**Subject:** Statement of Evidence for Proposed District Plan (PDP)

## Hearing 14 - Urban Zones

Fig. 1: Bulk & HIRB. Street section to illustrate the general concept of Height in relation to Boundary (HIRB) - example for several urban zones, as viewed from street level

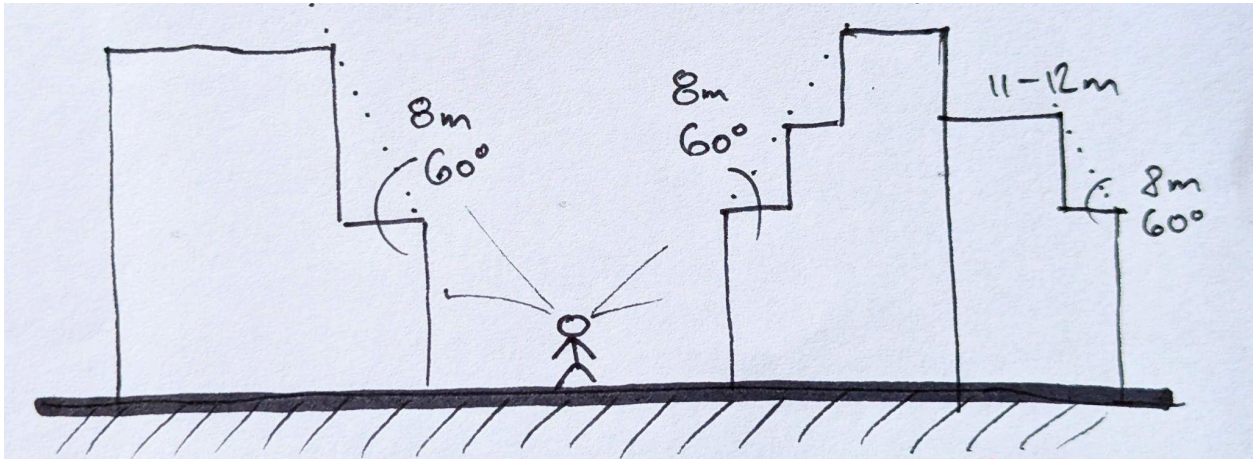
- **Maximum Height:** 12m.
- **Height in Relation to Boundary (HIRB):** No control between MUZ sites (as per PDP: MUZ-S2). However, for facades facing a public street (frontage), for example, a 60-degree recession plane at 8m above ground level should be introduced. This allows for taller buildings but requires upper levels to be set back, reducing perceived bulk at street level.
- **Setback:** 3m from residential or open space zones only (as per PDP: MUZ-S3).

- **Lower the proposed central zones along the street**  
Preserve a village character at the town's core by maintaining a lower, more human-scaled built form along the ridgeline at the building frontage, defined by HIRB.  
Priority level: CRITICAL

- **Frontage HIRB:** Apply HIRB to street frontage in relevant urban zones to reduce building bulk & retain a "village character"
- **Strategic use of topography:** When considering height restrictions and rezoning, apply a holistic approach that uses topography strategically in order to balance growth and character issues.
